Index 102-606 Two-Lane, Two-Way, Work Within the Travel Way-Signal Control

Sheet 1: Revised General Notes; Added Lane Closure Detail from Sheet 2 and New Detail for Side Roads Intersecting the Work Zone; Deleted Conditions; Renamed Index.

COMMENTS AND RESPONSES

| LAST REVISION 11/01/20 | REVISION | DESCRIPTION: | | FY 2021-22 STANDARD PLANS | TWO-LANE ROADWAY, LANE CLOSURE USING TEMPORARY TRAFFIC SIGNALS | INDEX 102-606 | SHEET 1 of 1 |

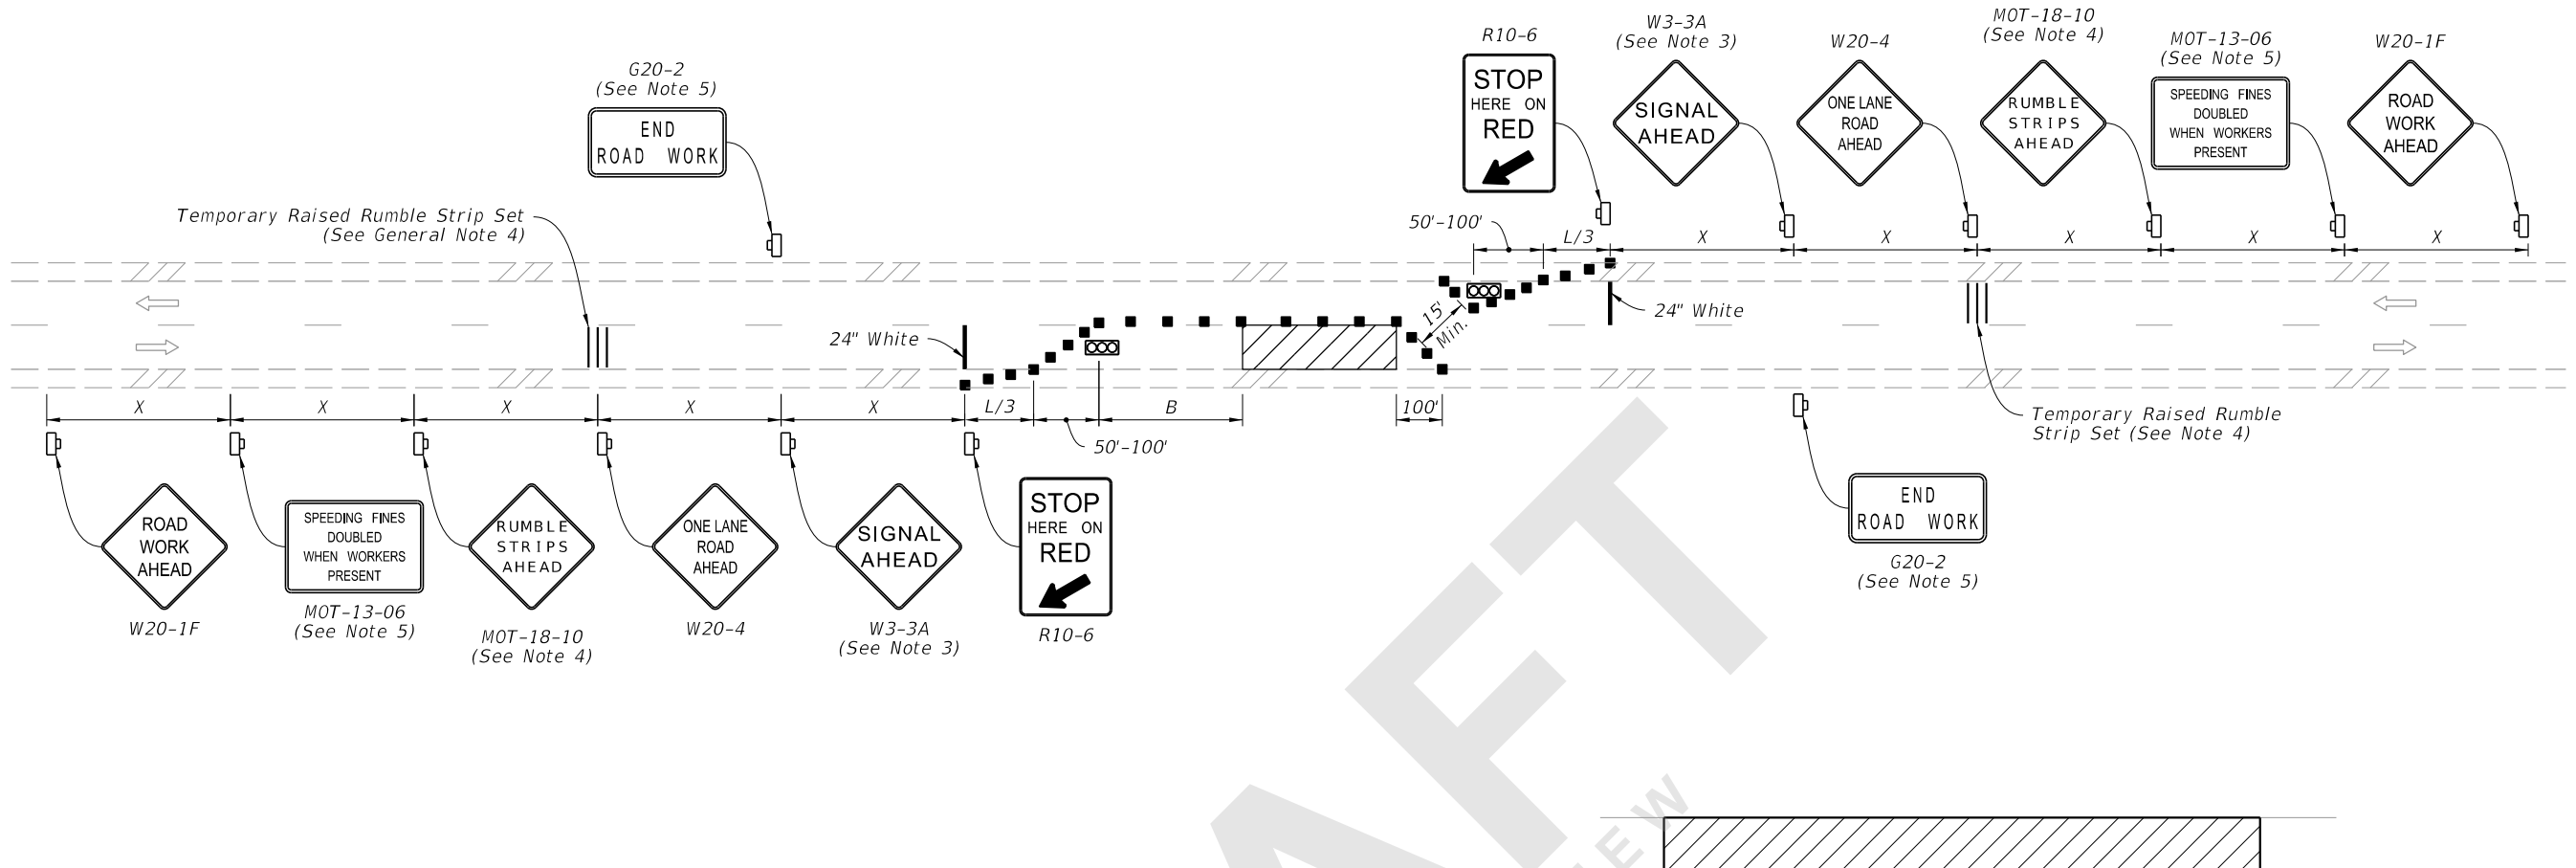
COMMENT: A distance of 80' to 150' is given from the temporary signal to the stop bar for the "Stop Here On Red" sign. Why? The sign should be at the stop bar, no need for the distance. This distance conflict with the dimensions given for the taper. The taper length is 100' from the signal to the shoulder edge, but the stop bar should be offset from this end of the taper making it around 110' (dimension not provided). That does not agree with the 80' given for the sign that should be next to the stop bar.

COMMENT: The spacing of channelizing devices in the taper section may be notated - limited to 10' maximum. This is for enhanced safety similar to spacing at business entrances per 102-600 sheet 9/11.

COMMENT: Not sure why we are deleting details related to side streets and bridges. We just had both of these used recently in a production set of plans. Recommend that the details should remain.

RESPONSE: *The intent of the detail is to have the 24" Stop Bar and "Stop Here On Red" sign aligned with each other. However, agreed that the dimensions for length of taper do not work well with the sign/stop bar spacing.*

Change Made: *For consistency with other Indexes and the MUTCD, the taper across the lane will be changed to 50-100', the taper across the shoulder will be 1/3L, and the Stop Bar (and associated sign) will be located at the end of the shoulder taper.*

RESPONSE: *Comment is acknowledged. The Department will continue to monitor innovative and new ideas for implementation within the Standards. It is unknown what affect the additional devices may have, if any; therefore, it will not be standardized at this time.*

RESPONSE: *Separate details for use across a bridge are not needed. The application as shown would be sufficient. Consideration should be given to the location, geometry, and length of bridge to determine the best location for the temporary signal; however, those same considerations are needed for all applications (not just bridges). The old details were created under the assumption that for short bridges, were there likely will be no shoulder, placing the signals off the bridge would be necessary. This not true for all bridge. As for Intersections within the work zone, an additional detail is included. Use of a signal for side roads/intersections is not supported in the Index, if appropriate, the proper details would be required in the TTC Plans.*
